ENGINEERING CHANGE NOTICE

1. ECN ~~131460~~
 Proj. ECN B-714-81

Block 5: B-714, Grout Vault Pair (218-E-16-102 & 103)(218-E-16-104 & 105)/ER8007

DETAIL 2
 SCALE: 3/4" = 1'-0"
 LEVEL PROBE
 PENETRATION RISER

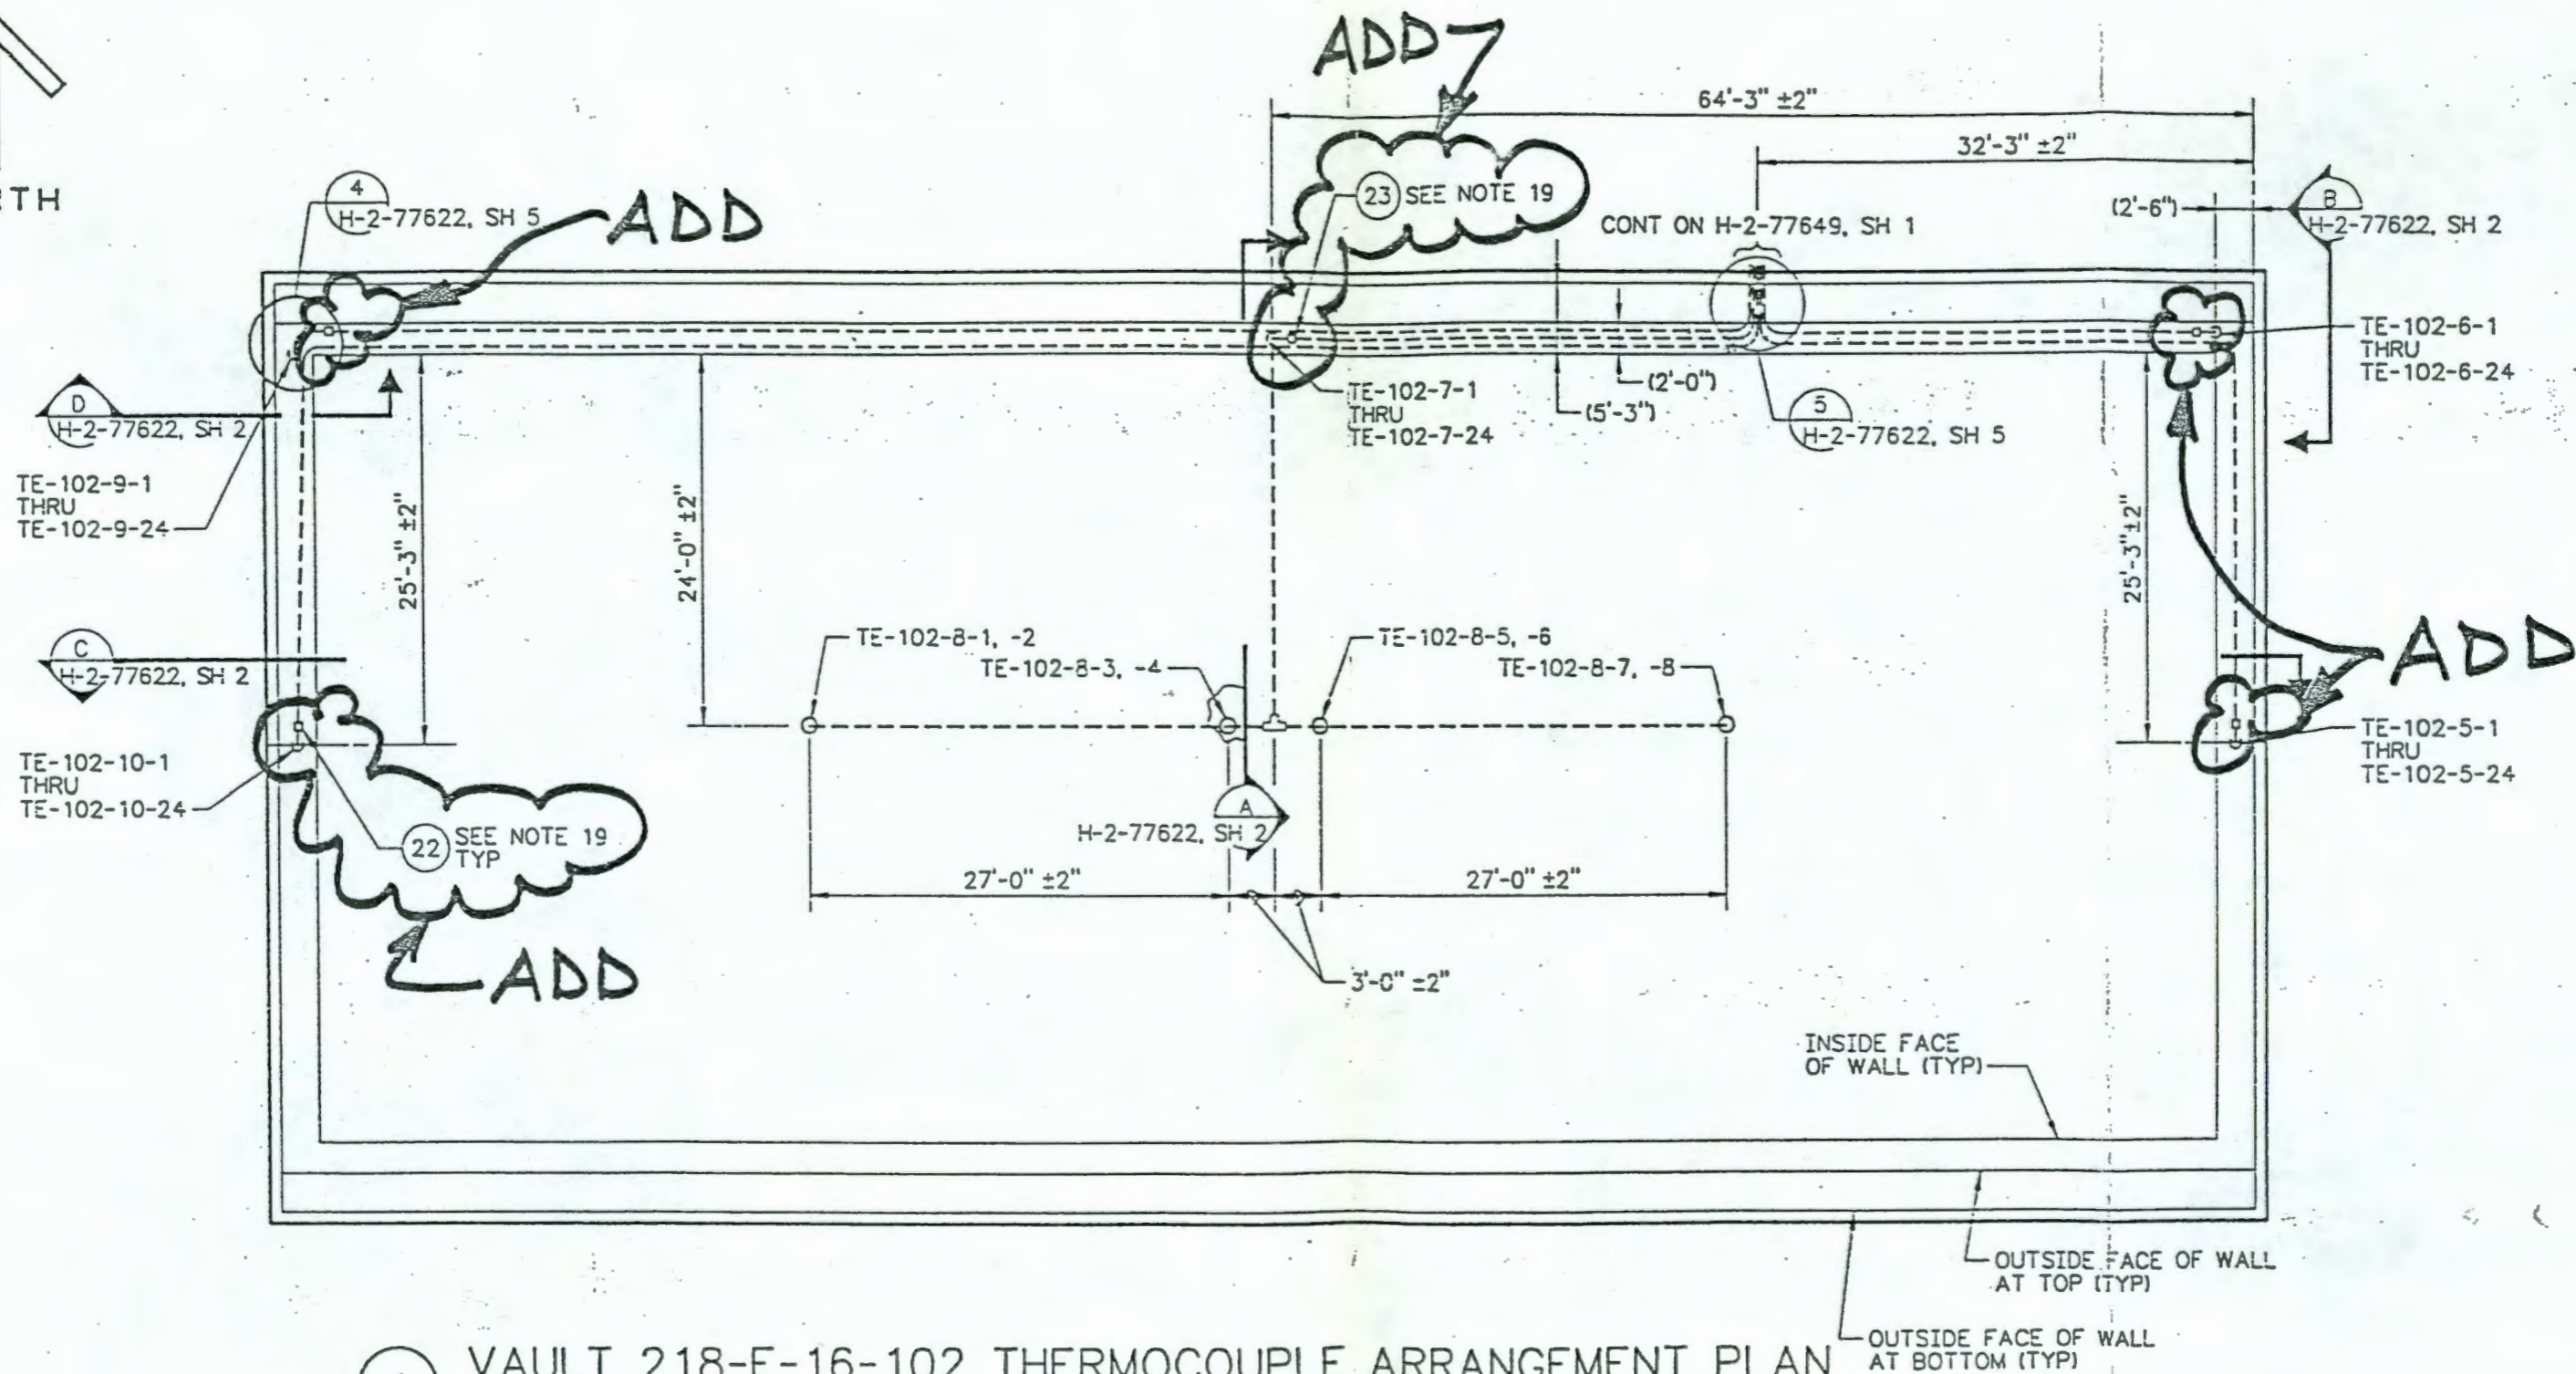
- A) Detail 2 (Z D6): Add note callout as shown on page 5 of this ECN.
- B) Note 4: Change "NOT USED" to read "REAM PIPE END TO NOMINAL INSIDE DIAMETER AFTER CUTTING. REMOVE SHARP EDGES & BURRS."

- A) Detail 2 (Z D6): Add note call out as shown on page 5 of this ECN.
- B) Note 4: Change "NOTE USED" to read "REAM PIPE END TO NOMINAL INSIDE DIAMETER AFTER CUTTING. REMOVE SHARP EDGES & BURRS."

ADD → SEE NOTE 4

1 VAULT 218-E-16-102 THERMOCOUPLE ARRANGEMENT PLAN
 CONCRETE TOPPING NOT SHOWN FOR CLARITY

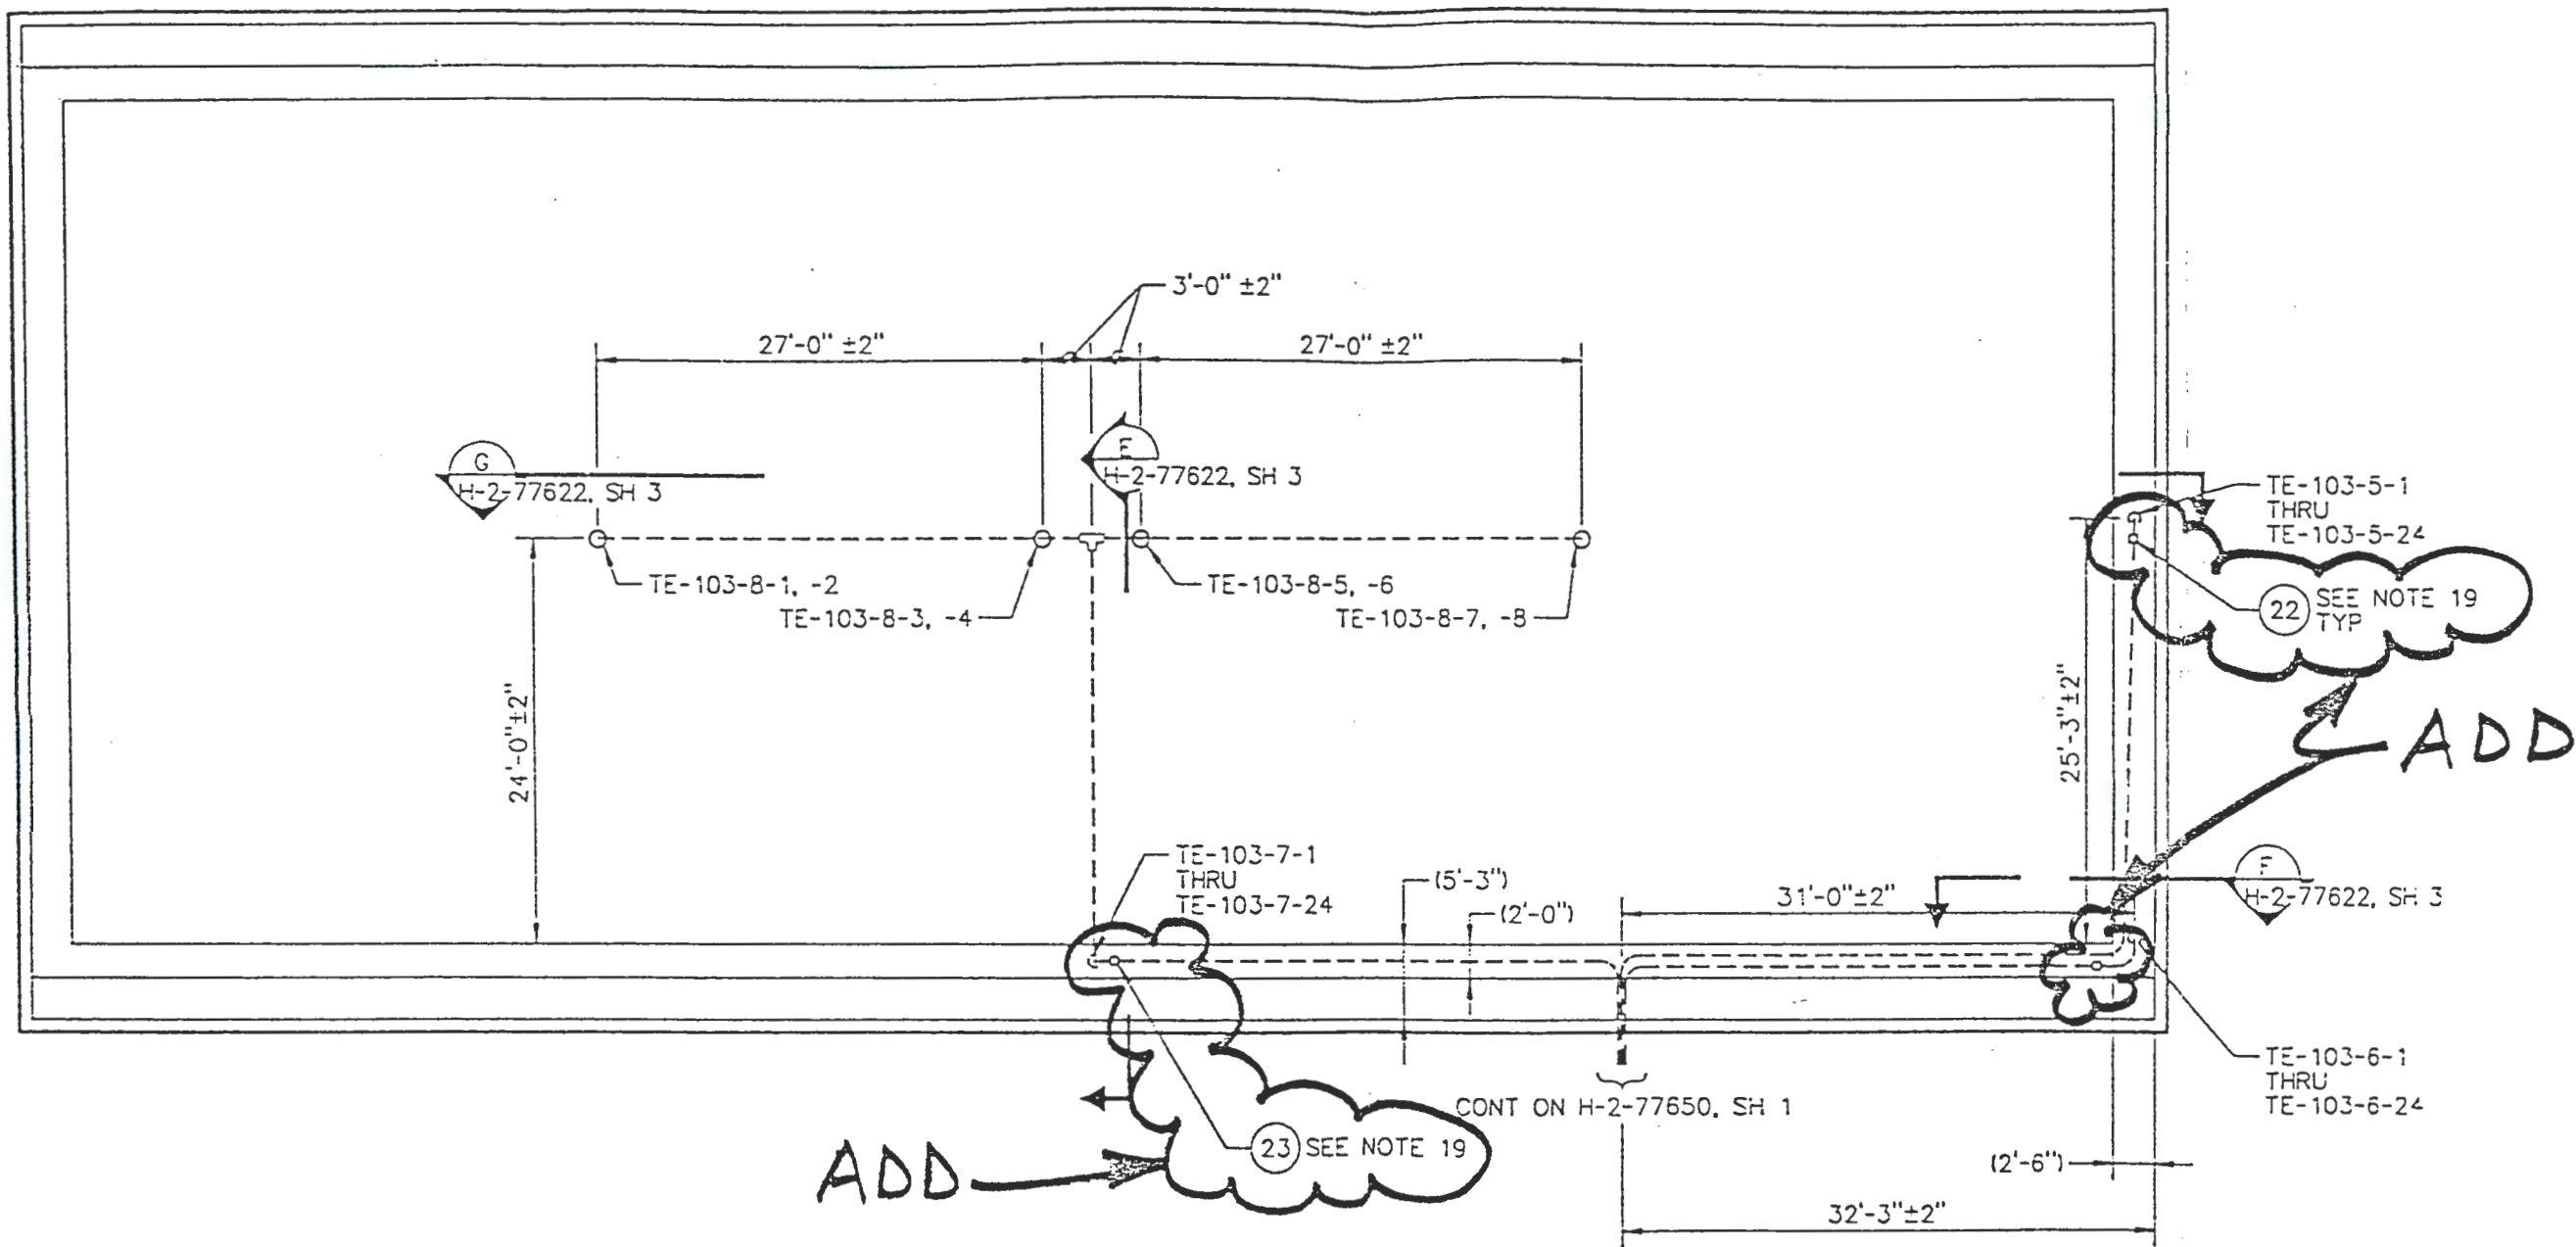
- A) Arrangement Plan 1 (Z E7, F6): Add PN 22 & 23 as shown on page 6 of this ECN.
- B) Arrangement Plan 2 (Z C4, B6): Add PN 22 & 23 as shown on page 7 of this ECN.
- C) Add note 19 as follows (Z F4):
19. TYPE C CONDULET CONDUIT BODIES MAY BE USED WHERE SHOWN AND AT ANY OTHER LOCATIONS NOT SHOWN THAT WILL AID CONSTRUCTION.
- D) Parts Lists (Z D1-2): Add PN 22 & 23 as follows

DETAIL 4
SCALE: 1½" = 1'-0" H-2-78493, SH 1

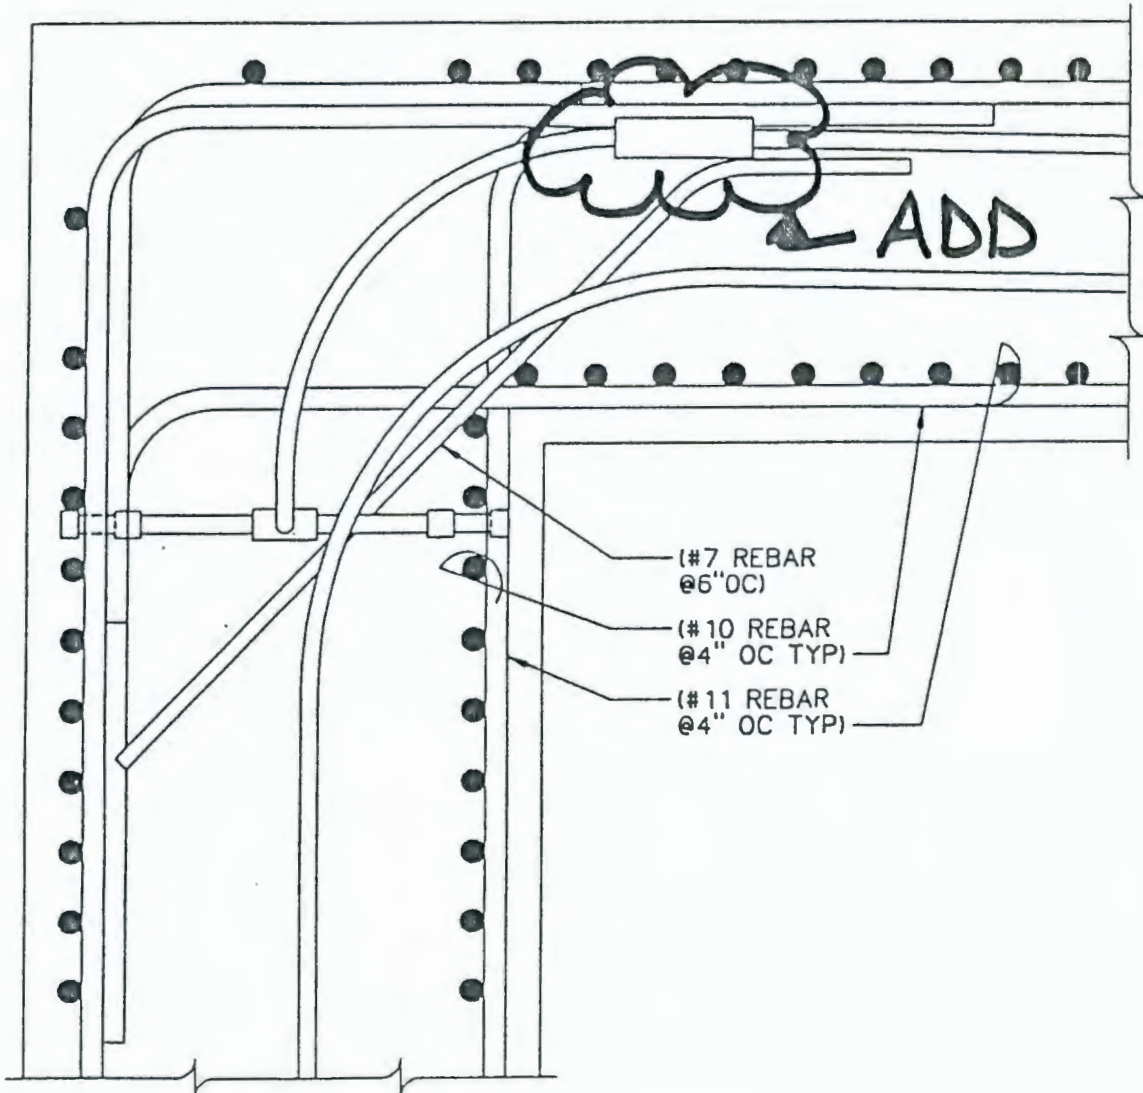
Detail 4 (Z B7): Add condulet conduit as shown on page 8 of this ECN.

Detail 4 (Z B7): Add condulet conduit as shown on page 8 of this ECN.
